**8-A-20-HZ**  
**APPLICATION FOR CERTIFICATE OF APPROPRIATENESS**

1708 Jefferson Ave. 37917  
Edgewood-Park City H-1

# Staff Report - Certificate of Appropriateness Application

File Number: 8-A-20-HZ

Google Streetview of chimneys, 2015

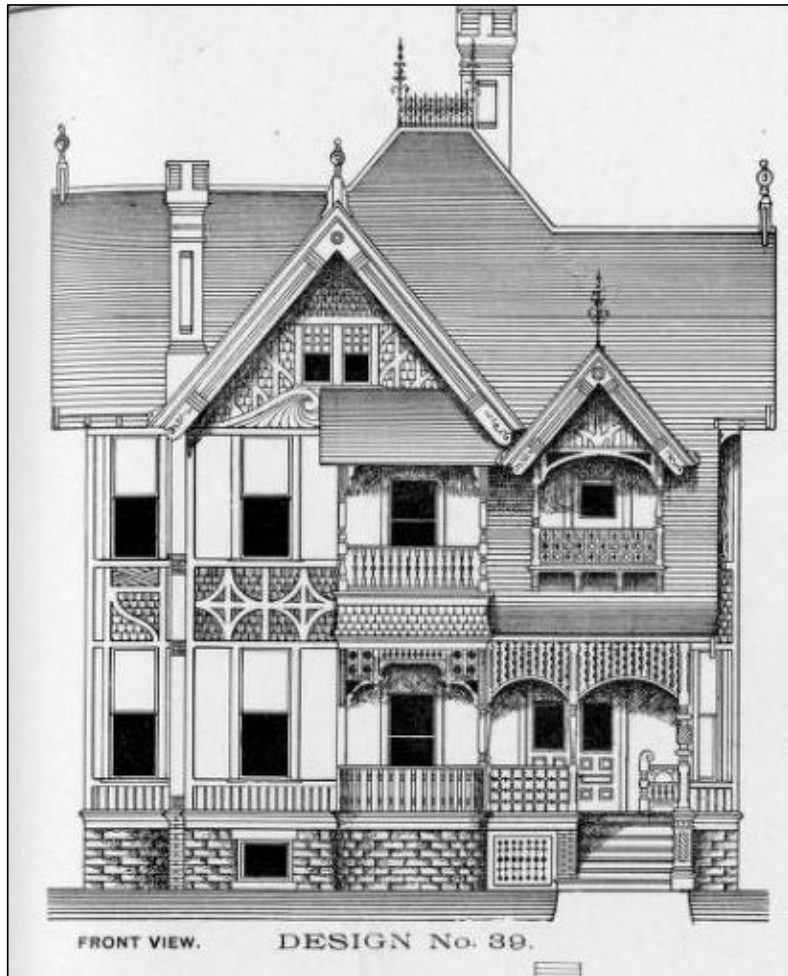
3. Few original features remain from the Barber design, including the left side exterior chimney detail and the wood fascia boards. The left side chimney has retained its distinctive masonry detailing along the exterior walls. The interior chimney has been removed to the roofline.

4. The applicant removed the historic chimneys to the roofline. While the chimney profiles above the roofline have been reconstructed (prior to the 1998 rehabilitation), they remain some of the few extant original features on the house. The two chimneys are character-defining features, characteristic of elaborate George Barber designs, and should be reconstructed. The bricks and mortar used in reconstruction should be appropriate for the historic masonry materials on the remaining chimneys and meet the specifications of Preservation Brief 2. Detailing on comparable Barber-designed houses in the neighborhood could be used as a reference.

Staff recommends approval of the reconstruction of the two masonry chimneys, with bricks, mortar, construction methods, and detailing appropriate for the original design of the house.
